Delmore

Consultation Overview Report

19 December 2025

Prepared for:
Vineways Limited

DRAWING TITLE MASTERPLAN -
UPDATED

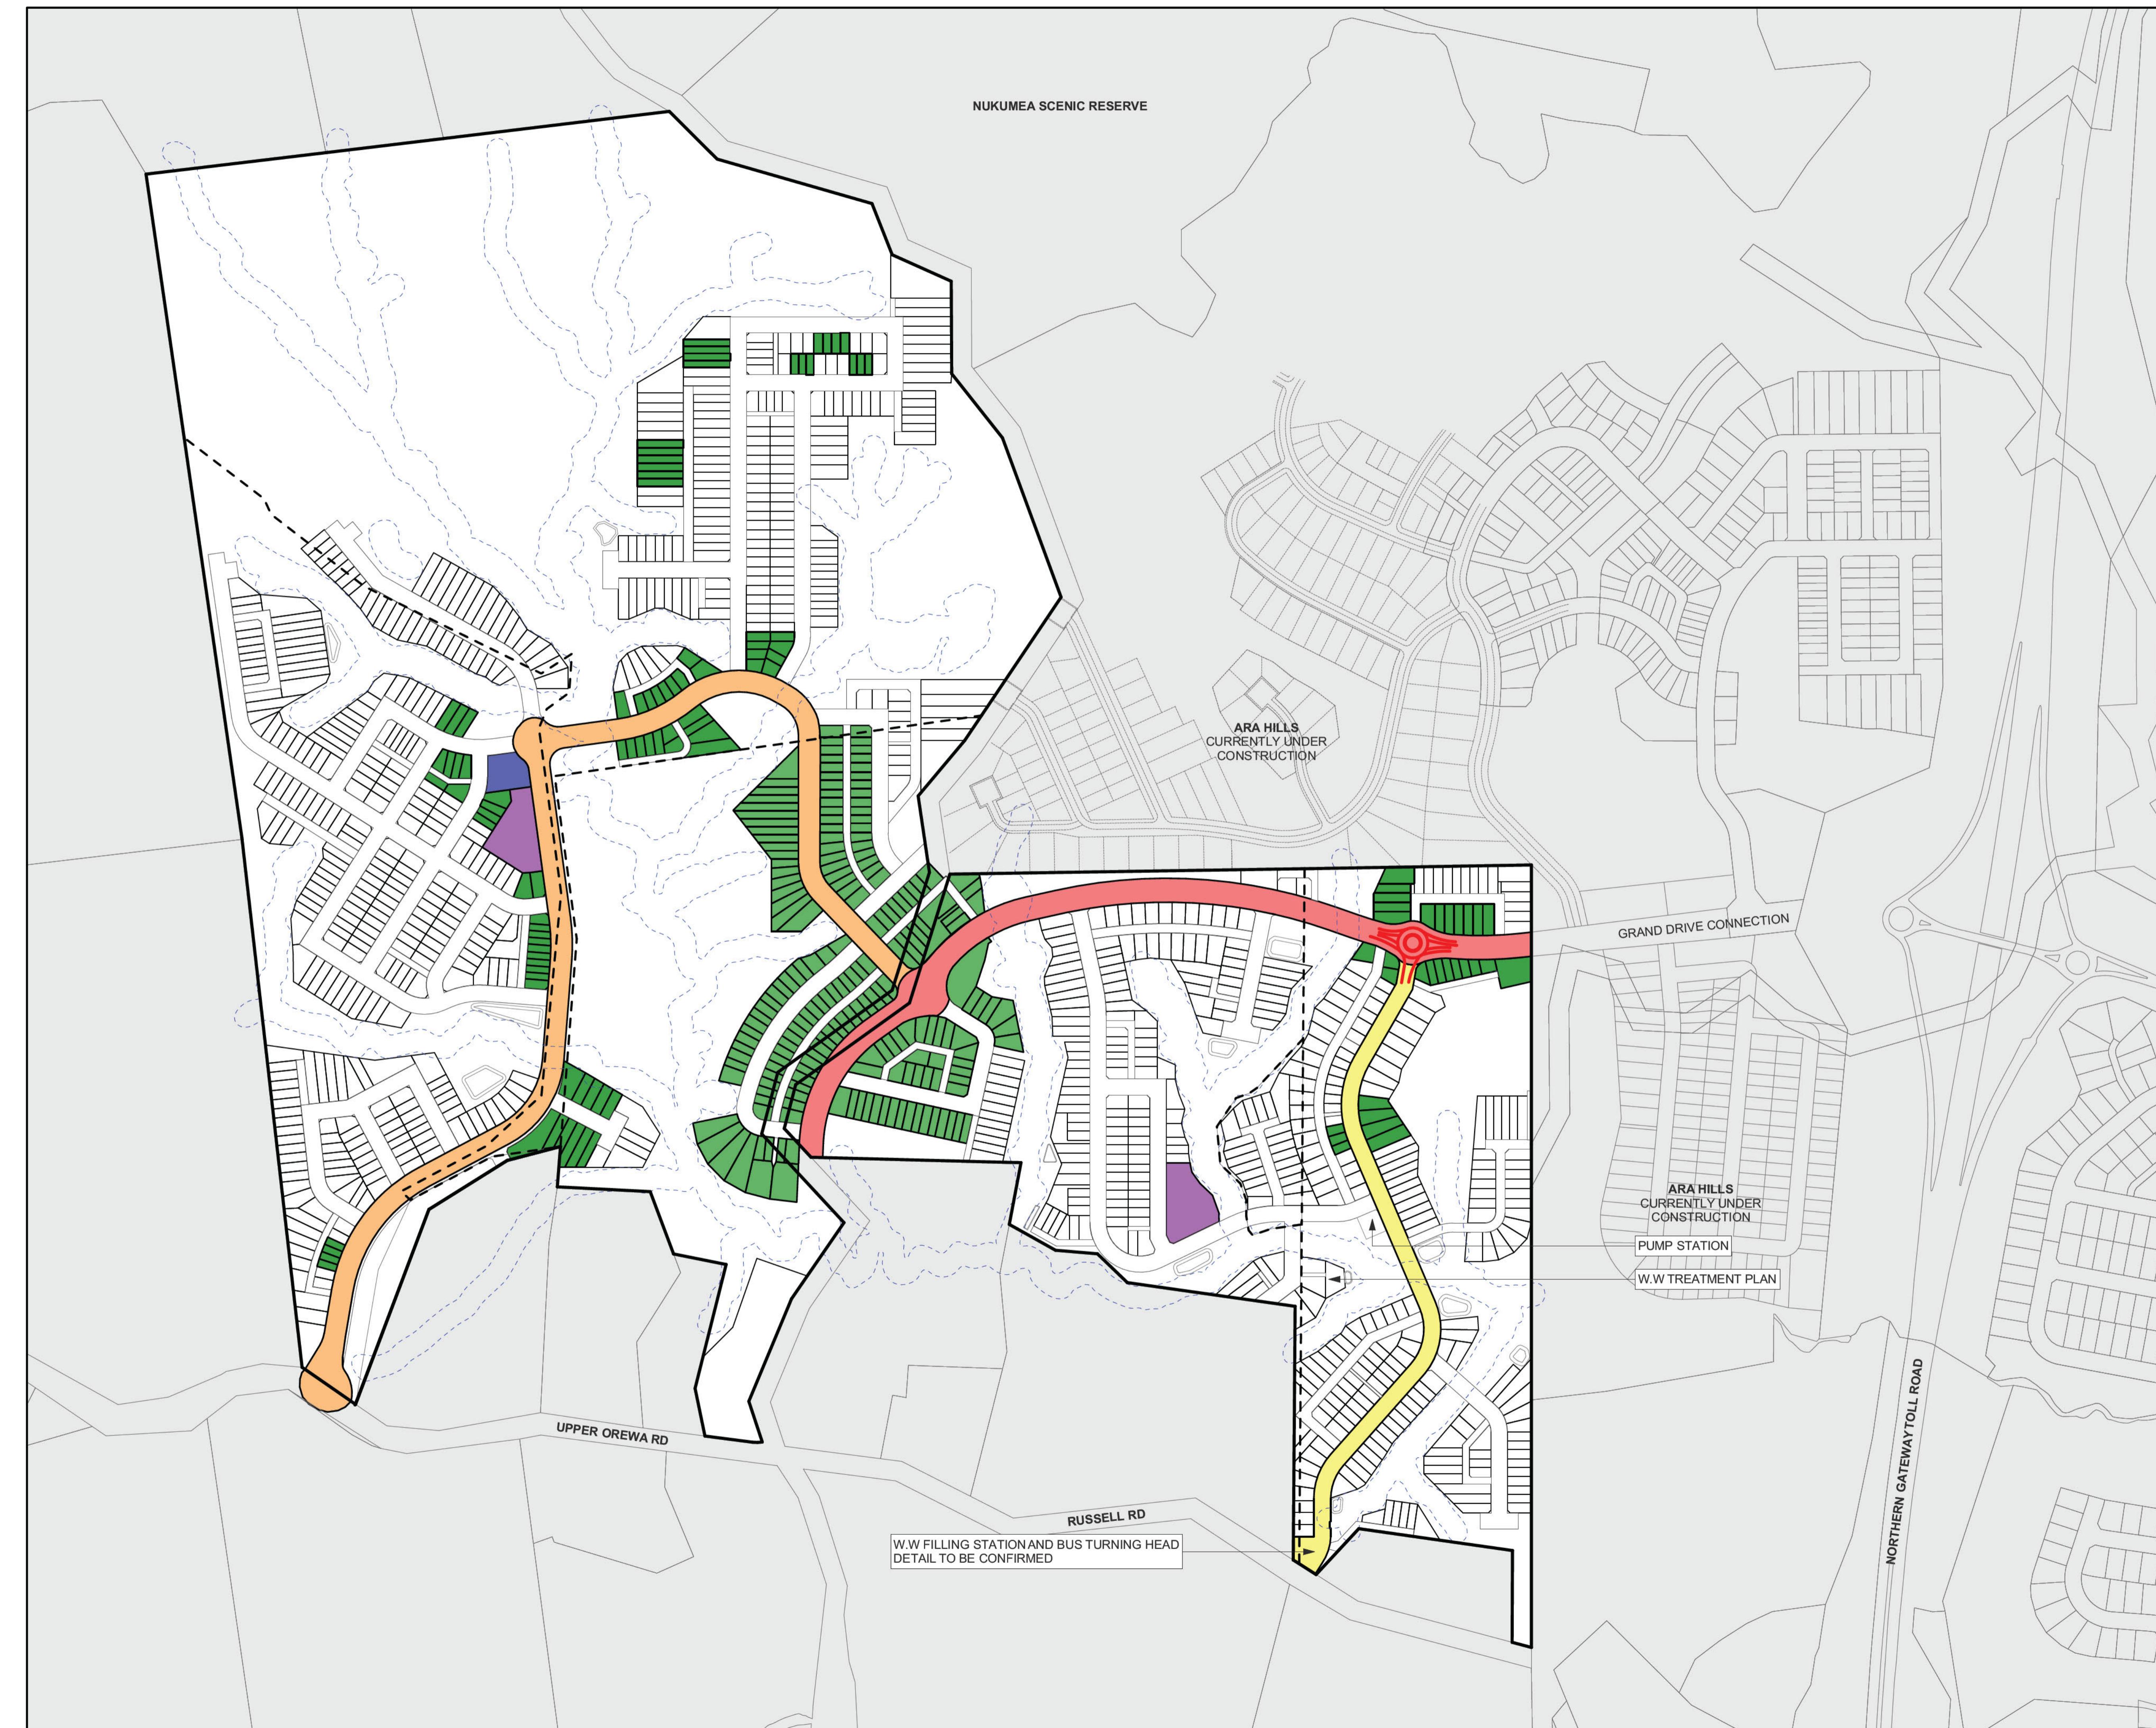
- 3) Drawing A101 shows typical cross-section diagrams for the different road types on the right-hand side, these show what is included in the cross-section and the overall width but not the widths of each element. However it appears to that overall widths will be sufficient to provide all of the elements shown for all of the cross-sections at the widths specified in AT's TDM, with the only exception being that some more space may be needed on some of the lower radius curves to allow for heavy vehicle tracking. There is space in the cross-sections for the collector roads for a 7m carriageway which could be suitable for use as a bus route.

- 9) The masterplan shows boundaries for Ara Hills in grey, but they have shown what appears to be the currently consented layout and not the plan change layout. While it is useful to see the consented layout, in case the plan change is not approved, please provide a version with the plan change layout also shown.

- 13) There is a paper road running between the east side of Stage 2 of Delmore and the west side of the Ara Hills site. The masterplan shows a local road connecting to this paper road, and the Ara Hills consented layout ends with two roads at the paper road. Whilst the Ara Hills layout may change roading infrastructure on the Delmore site the frontage to the Delmore land should be upgraded to the boundary with kerb and foot path on the Delmore side to provide ability for connection and integration with Ara Hills. Refer comment on item 18.

[Delmore to provide additional information.](#)

[Delmore to provide additional information.](#)

Super Lots

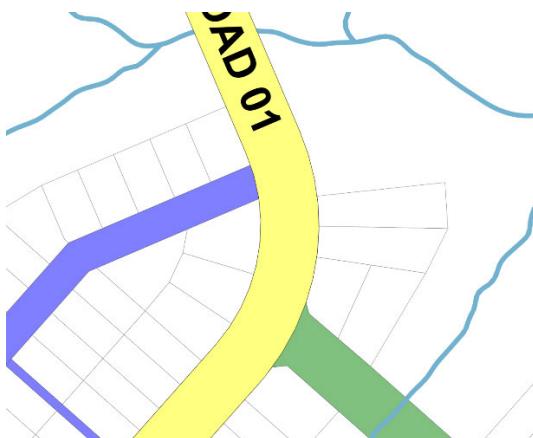
- 6) Two new super lots next to the NoR6 road are proposed. Information is needed to confirm that there is a feasible way to develop these in future without having lots with direct access to the NoR6 road and for any new intersections onto NoR 6 to be located in a location which is both safe and practical. Ideally the super-lot on the east side of NoR6 would get all access from the local road on its east side, while the super-lot on the west side of NoR6 would get access via Road 5. This could be conditioned.

Delmore to provide additional information.

5. Paper Roads

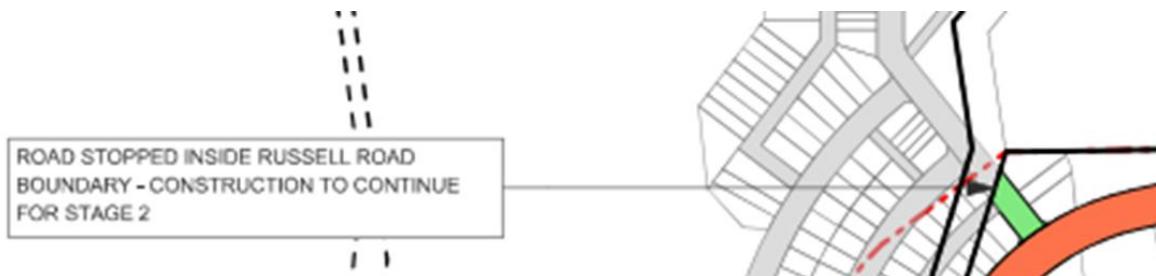
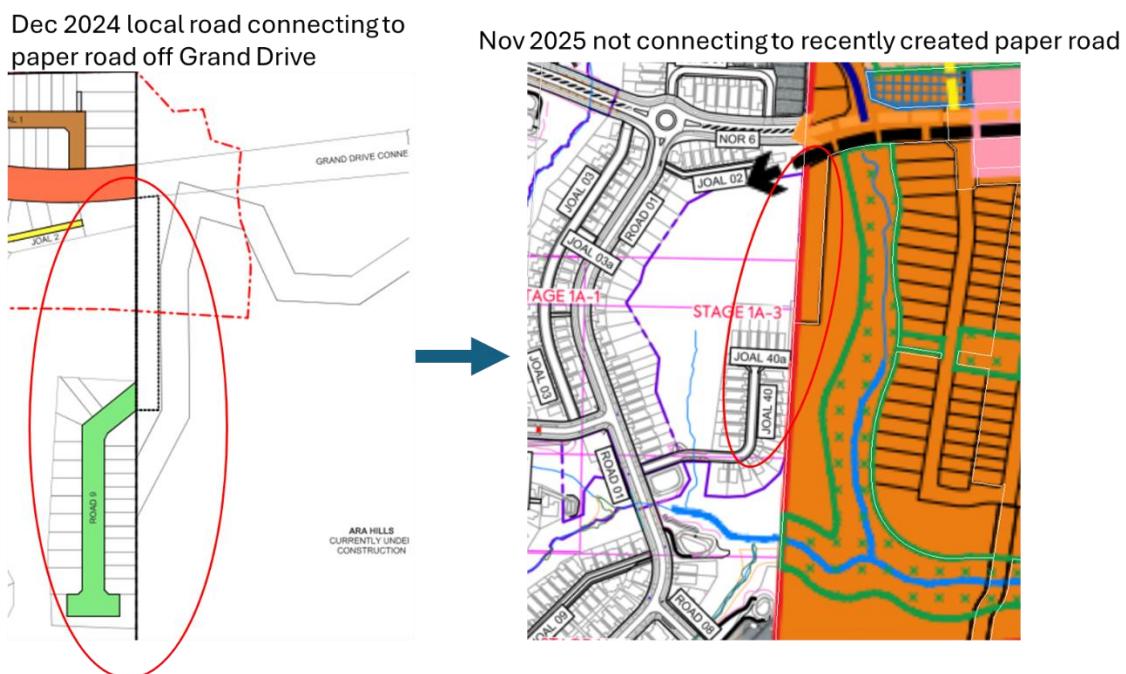
The section of paper road (now shown in blue on new plan) are part of a large network of unformed legal road as shown in purple below. It is important that this network remains fully connected.

The plan provided at the pre-app meeting with AT Property Services on 17 December 2024 relating to an intended future closed road application showed a proposed local road connecting to the unformed road and onto the NOR 6 road, which would provide continuity of access to the unformed road network. It is not clear why the proposed network has changed to connect at road 7 and the original local road shown green below has now become a JOAL.

In addition, AT is concerned that the recently created paper road on the Delmore/Ara Hills boundary no longer has a direct connection through to Delmore as was previously proposed to AT. JOAL 40 was to be a public local road to connect with the existing paper road. As advised to the applicant at the pre-app meeting with AT Property Services on 17 December 2024, any proposed reconfiguration of the development site that impacts any sections of the unformed legal road on the site, will require the applicant applying for a road stopping.

Delmore to provide additional information on the above points. AT would like Delmore to consider a walking link from JOAL 40 through to Grand Drive. Any such link would not necessarily need to follow the location of the paper road on the adjoining ARA Hills site.

6. MoE school site active mode connections

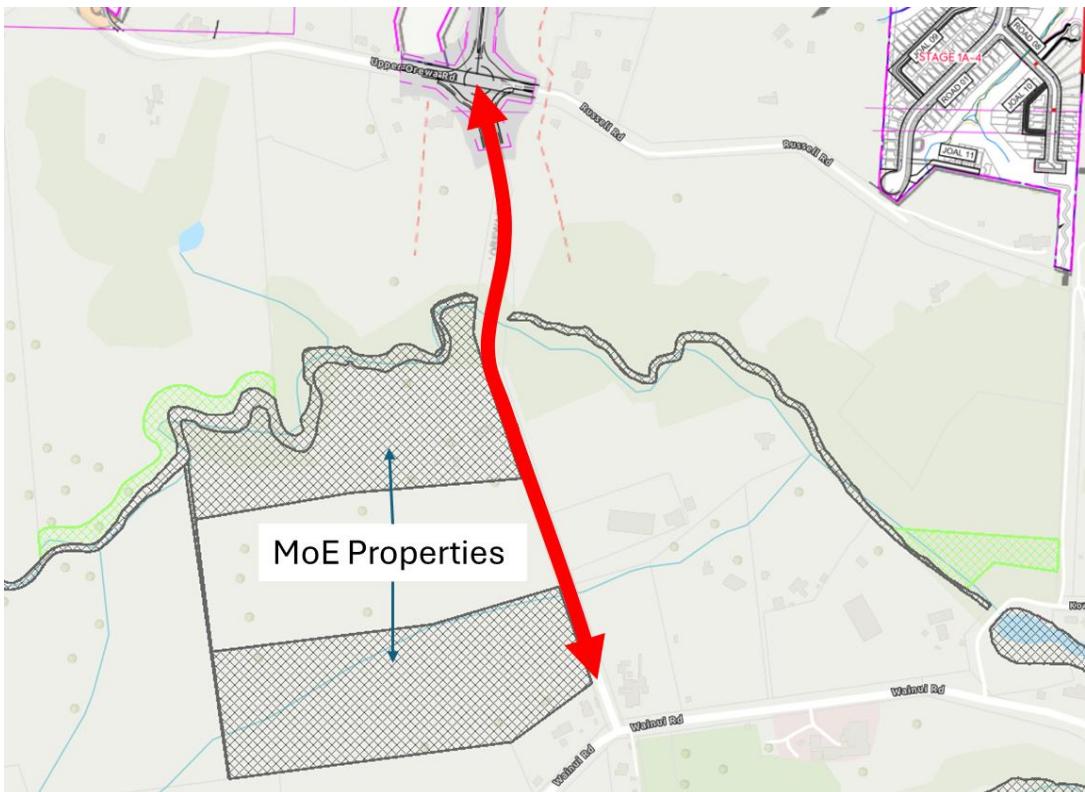
The provision of infrastructure for active modes between the Delmore site and future school on Upper Orewa Rd is still an outstanding issue. This needs assessment of infrastructure requirements and draft triggers within conditions. To be built when school opened. Condition on landuse consent, and subdivision consent as an encumbrance.

Noted by Delmore, not agreed.

10. Potential Changes to Grand Drive Interchange

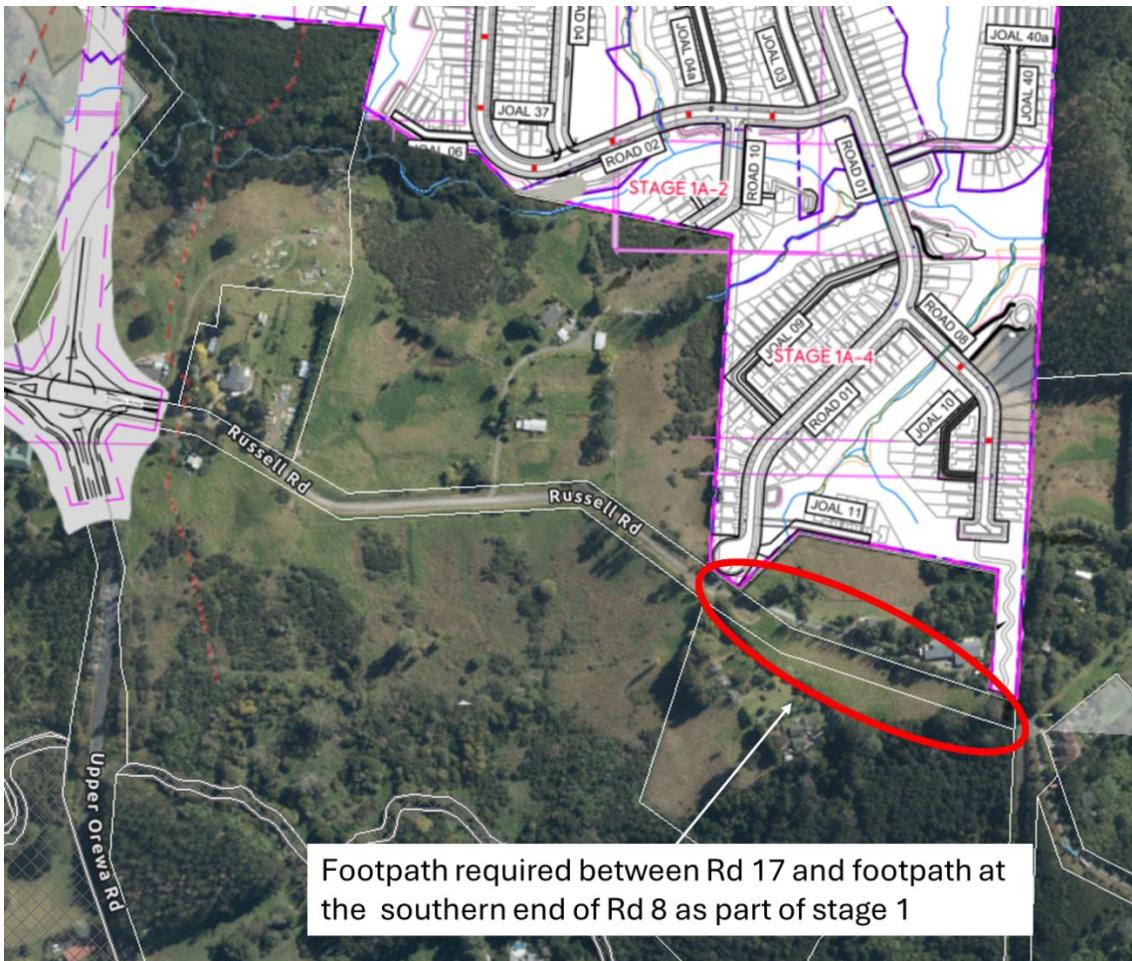
A monitoring condition on the Grand Drive interchange is supported in principle. However, the proposed wording of the mitigation condition puts decision making with the independent engineer rather than Council and NZTA (the requiring authority). Feedback should be sought from NZTA as the requiring authority on any works to this interchange. The condition should therefore be extended to ensure that information supplied includes a summary of consultation/discussions undertaken with NZTA as the designating authority.

[This relates to a condition imposing a trigger on a slip lane in the future. Delmore to look at the condition to add additional text to ensure discussions with NZTA are documented and forwarded to AT.](#)

[Delmore further advised that the proposed upgrades to Upper Orewa and Wainui Road are intended to take pressure away from the Grand Drive interchange. A sensitivity analysis needed to be undertaken regarding the extent of interchange use. Any upgrade works would need to be undertaken before there is an issue but after some level of development has occurred.](#)

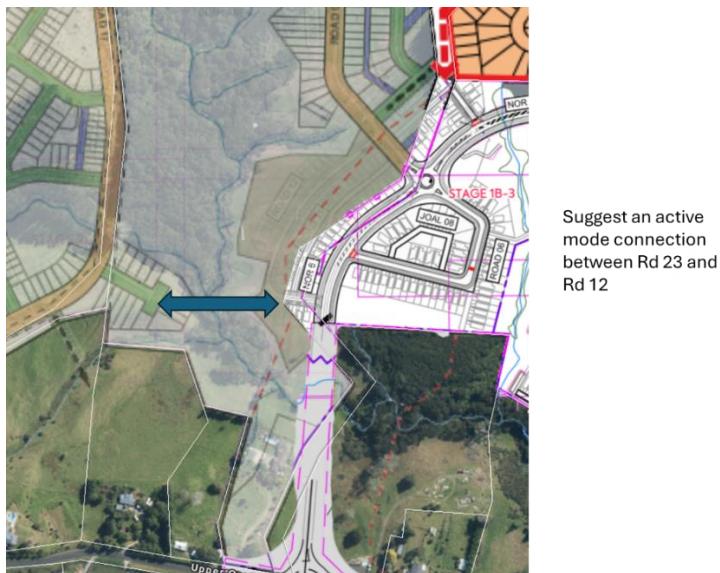
In respect to bus stops for Stage 2, the following pairs should be investigated:

- On Road 5 between Road 7 and Grand Drive
- On Road 5 near Road 13 and Road 14
- Either near the roundabout on Road 17 or on Road 17 near Road 21.
- On Road 17 near Road 25.

The bus stops need to have the space and foundations for having a bus shelter.

Delmore to review and advise further.
